July 18, 1988

The State of Alaska has reviewed the National Park Service (NPS) draft Environmental Impact Statements (EISs)/Wilderness Recommendations for the Gates of the Arctic National Park and Preserve, Wrangell-St. Elias National Park and Preserve, and Lake Clark National Park and Preserve (NPPr). The following letter is submitted on behalf of state agencies and represents a consolidation of state concerns and comments. The state's comments are presented in four sections as follows: Introductory Comments; Comments on the Specific Wilderness Recommendations; General EIS Comments; and Page-specific Comments.

TITLE: Wilderness Comments
GAAR/WRST/LACL

NABESNA QUAD MAP D

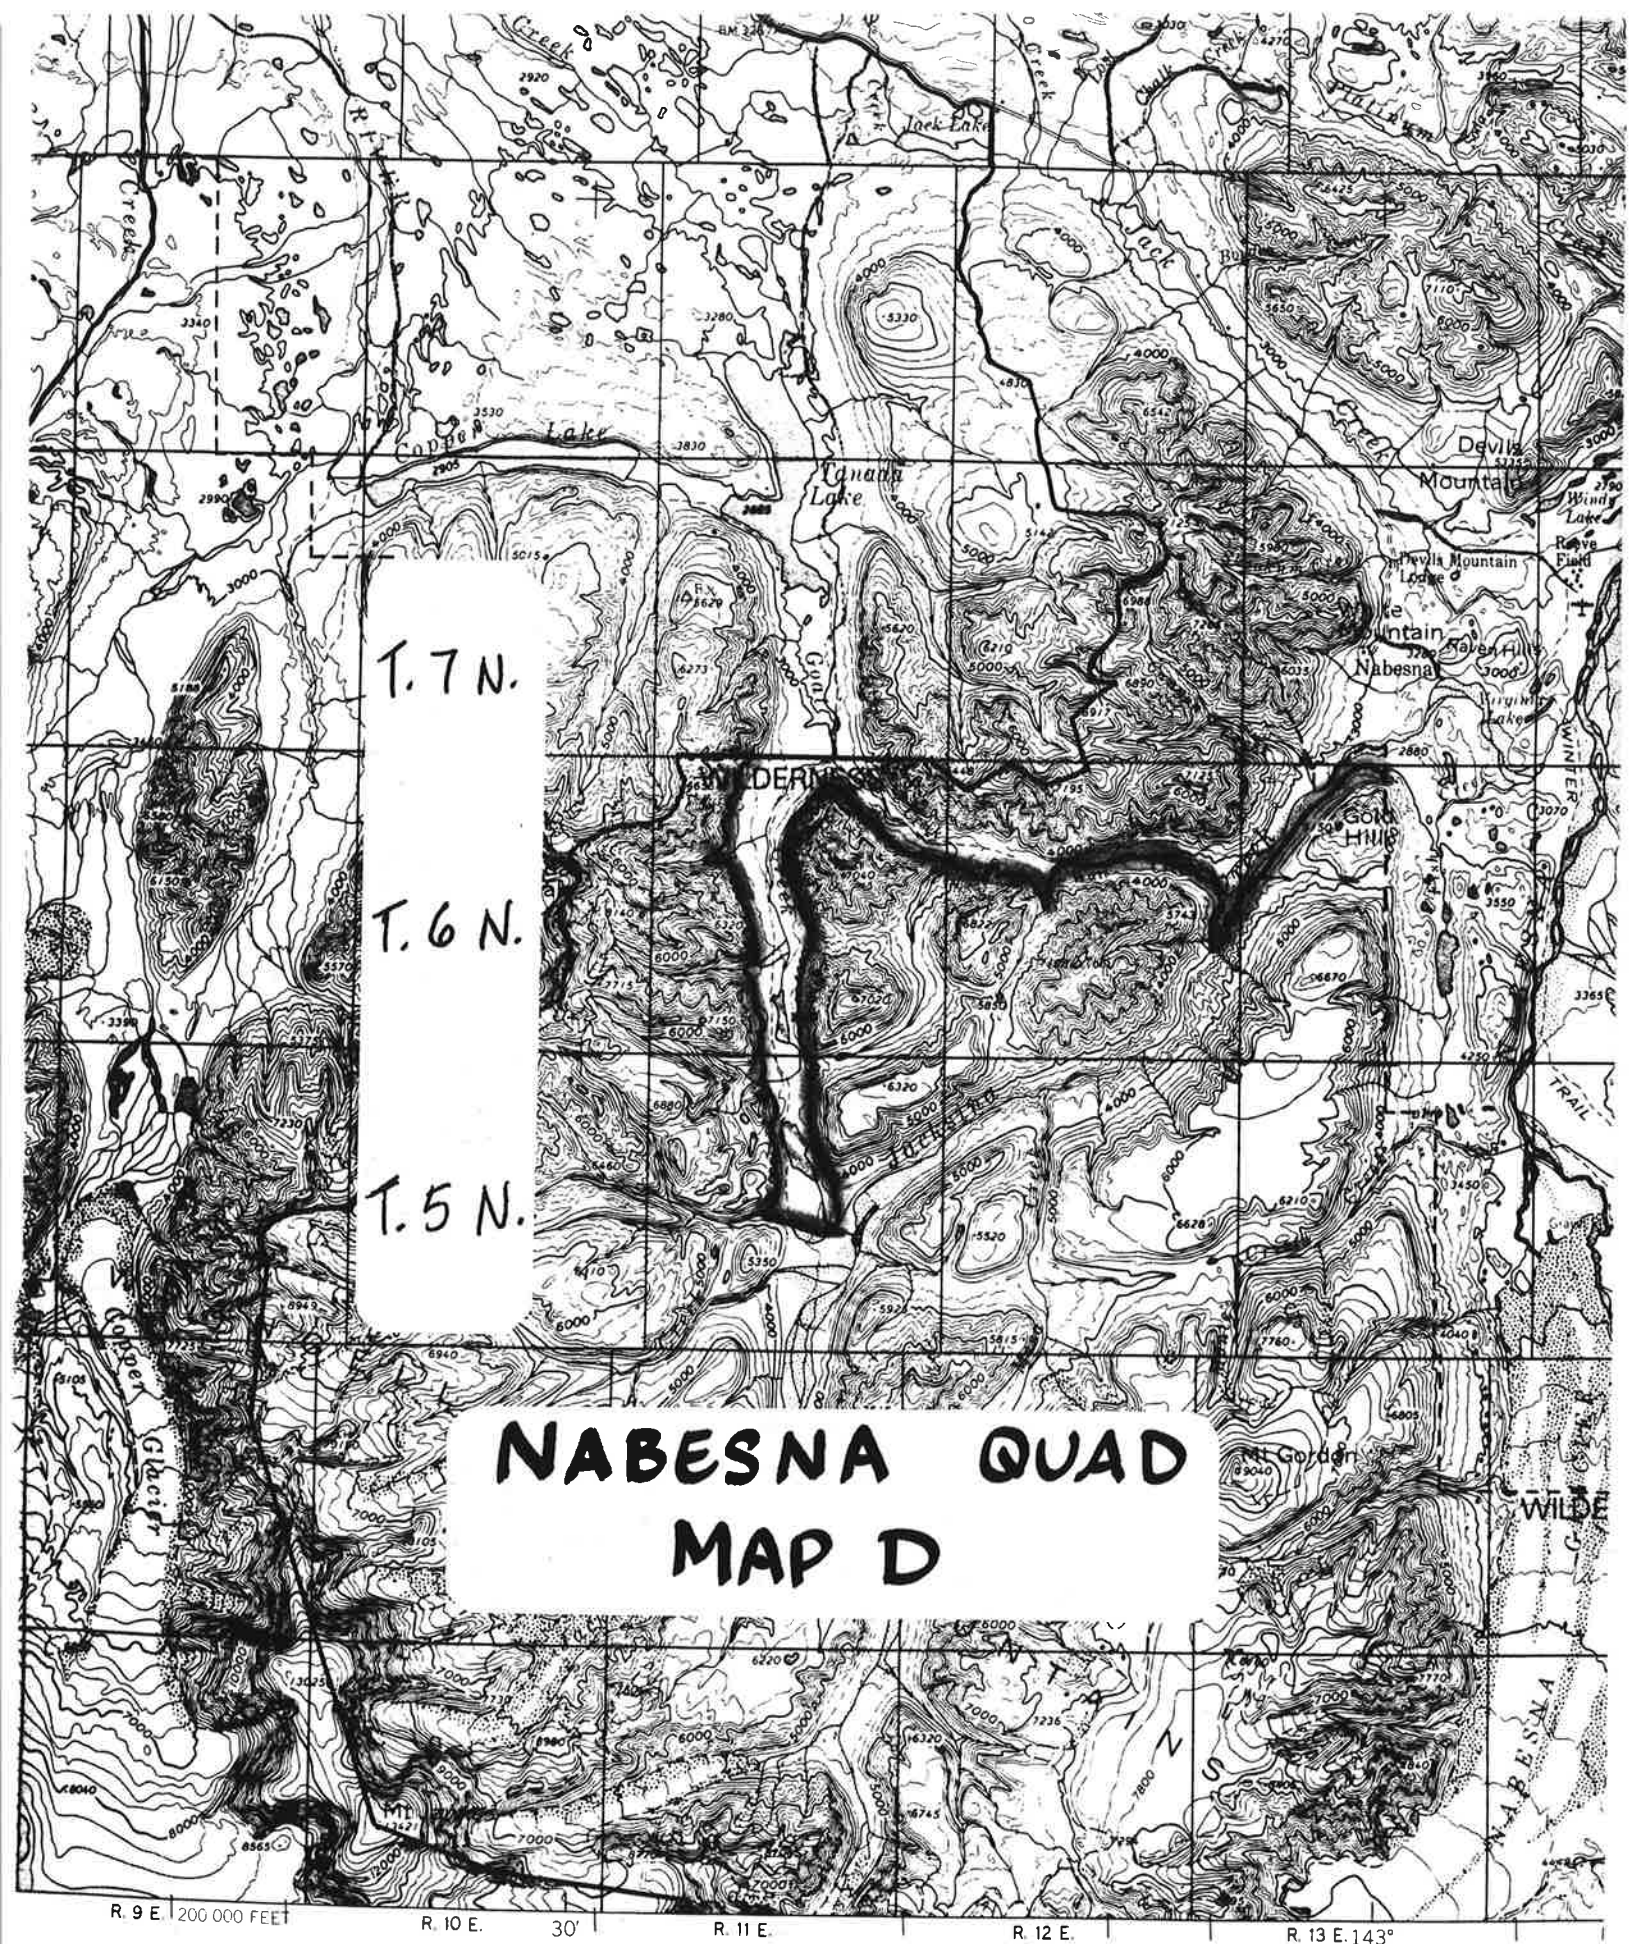
Exclude Sheep Lake (T. 6 N. R. 11 E.) and Grizzly Lake (T. 5 N. R. 11 E.) from the Wilderness recommendation. This could be accomplished by moving the boundary to the 4,000 foot contour along Goat Creek to the junction of Jacksina Creek. (See Map D.)

- 1) These lakes and the access trail to them are heavily used and therefore inappropriate for Wilderness. Access to the lakes and surrounding area has traditionally been gained by aircraft, ORV's and horses, creating a difficult management situation in its present status. Excluding the lakes and trail from Wilderness will help alleviate these management conflicts.
- 2) The 4,000 foot contour boundary would be easier to recognize in the field than the straight line boundary cutting across Goat Creek.

Redraw the Wilderness boundary between Goat Creek and Gold Hill along more easily recognizable features. (See Map D.) From Goat Creek, the boundary should follow the south side of the valley floor along Pass Creek, excluding the existing trail from Wilderness. At the pass, the boundary should follow Wait Creek to the 3,000 foot contour, then to the north end of Gold Hill at the same elevation.

- 1) Improves identification of the boundary in the field.
- 2) Excludes Pass Creek trail from Wilderness.

**McCarthy &
BERING GLACIER
QUADS
MAP E**

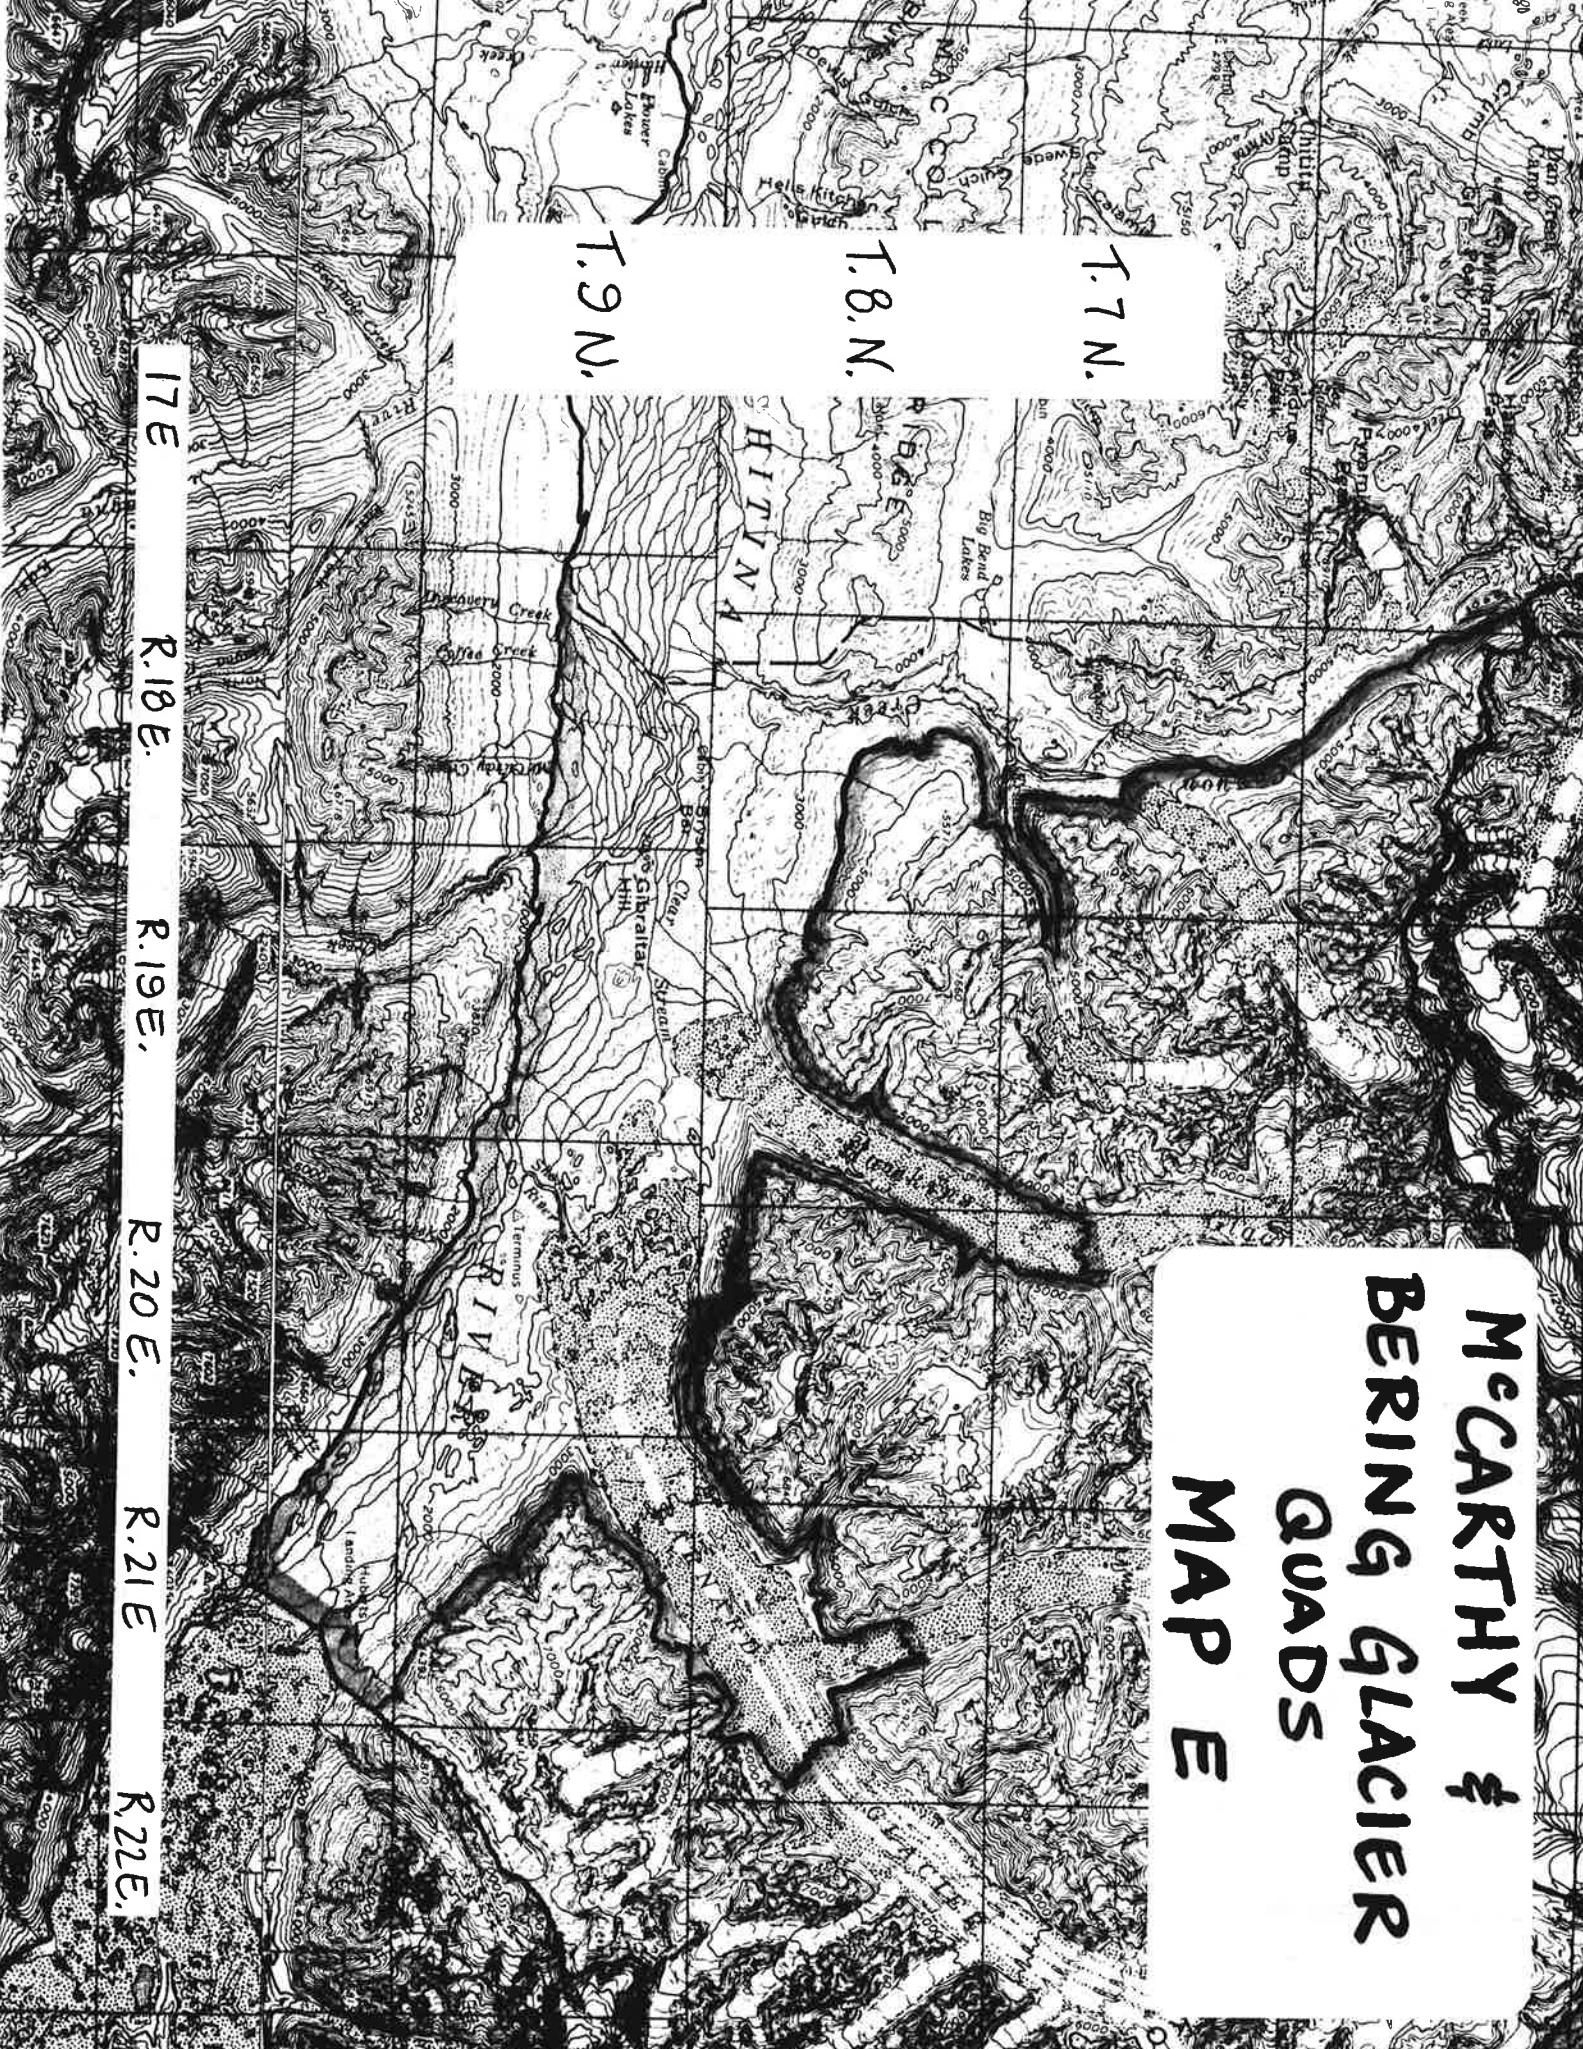
Modify the boundary from Gold Hill to the Nabesna Glacier along the 4,000 foot contour. (See Map E.)

- 1) This relatively minor change places the Wilderness boundary along the steeper slopes above the Nabesna River, thereby alleviating possible confusion in and south of the Fish Creek drainage. The crossing of the Nabesna Glacier could remain unchanged or be moved to the 4,000 foot contour.
- 2) The 4,000 foot contour more nearly approximates the original congressional boundary.

Exclude the portion of the upper Chitina Valley in the vicinity of Bryson Bar from existing Wilderness. (See Map E.) Ideally, the state suggests that the Wilderness boundary follow Canyon

Creek to T. 7 S., R. 18 E., then to the slope of Canyon Creek at the 4,000 foot contour, then continuing east across to Barnard Glacier, then to the face of the Chitina Glacier, before re-joining the park/preserve boundary south of the Chitina River. At a minimum, the land below the 2,000 foot contour in this area should be deleted from Wilderness.

- 1) This area is heavily used for recreation, including use of aircraft, ORVs, and other mechanized equipment. It has reportedly been a difficult area for NPS to manage because of traditional uses, including extensive recreational access. This boundary adjustment would reduce these conflicts.
- 2) This area contains active horse grazing leases, (e.g., at Bryson Bar.) Wilderness designation may jeopardize these leases and the historical use of horses in the upper Chitina Valley.
